ADDENDUM #3

Harbor Beach Community Schools
BP #1 - Office Addition and Renovations
October 21, 2026

Addendum No: #3

Project: Harbor Beach Community Schools
Phase #1
Renovations and Office Addition

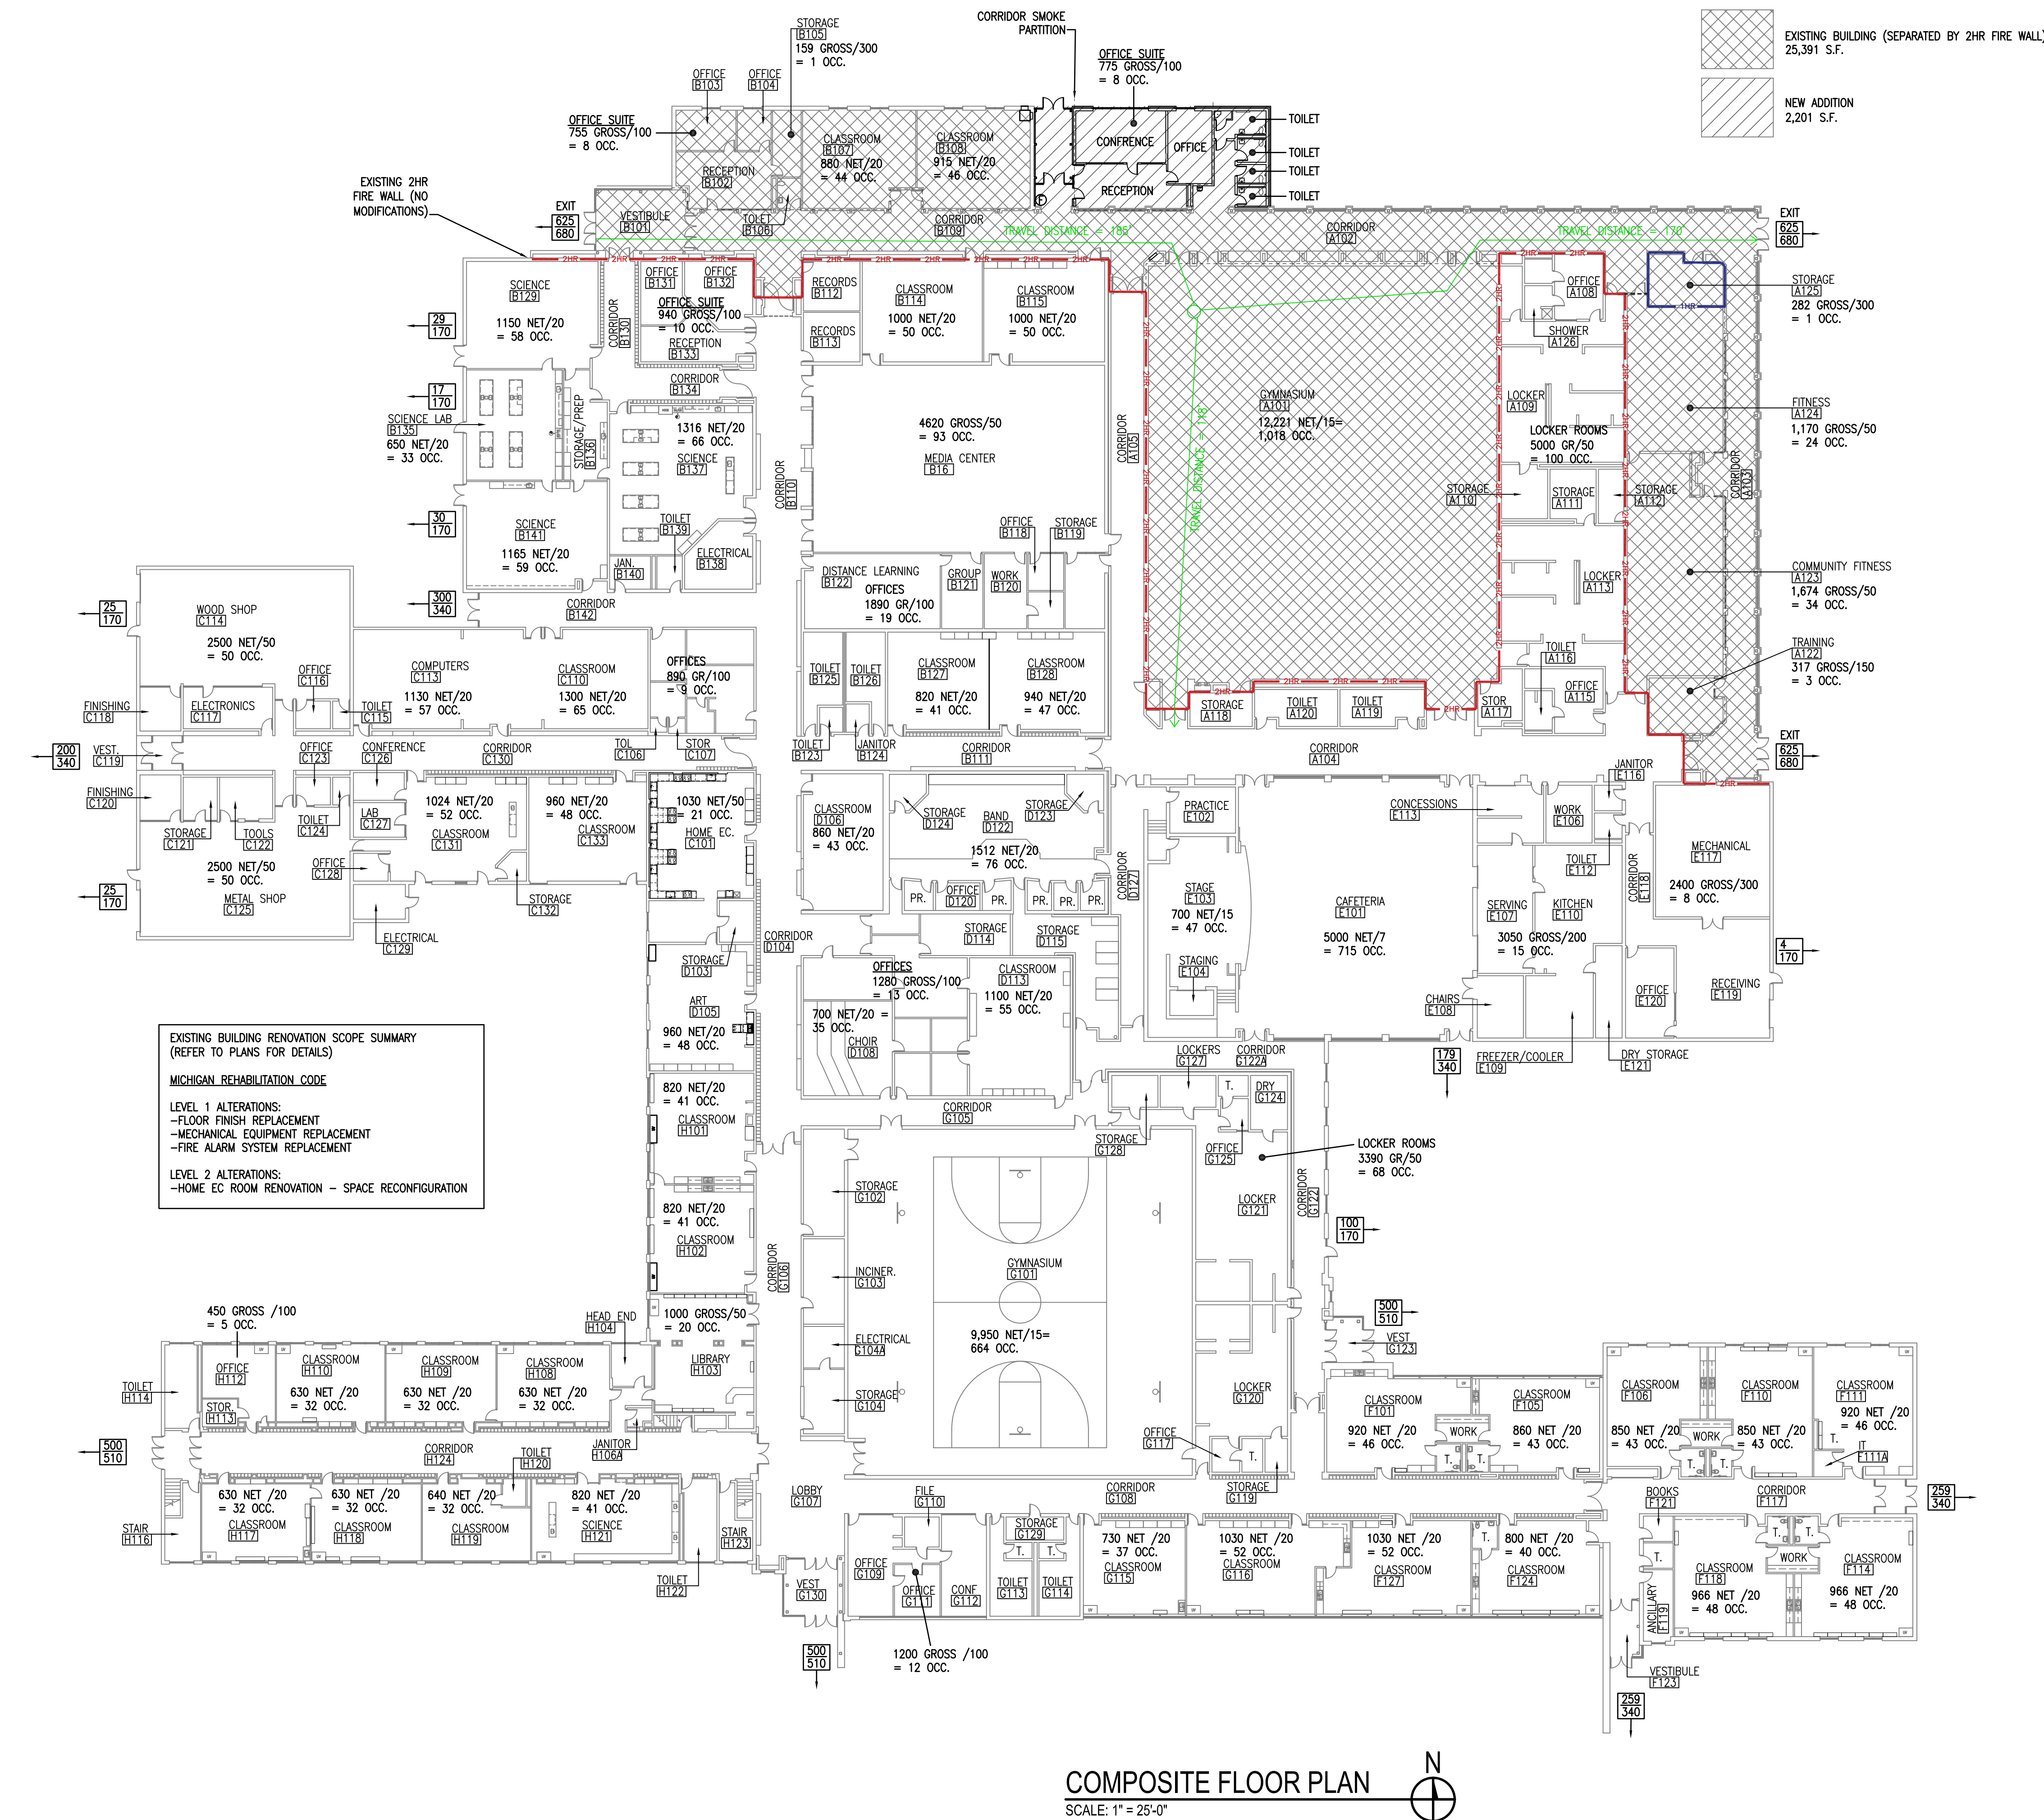
- Item 5: Updated Life Safety Plan (for reference and plan review)
Revised Sheets: G0.1
- Item 6: Removed note referencing acoustical metal deck. No new acoustical deck in addition.
Revised Sheet: S2.0
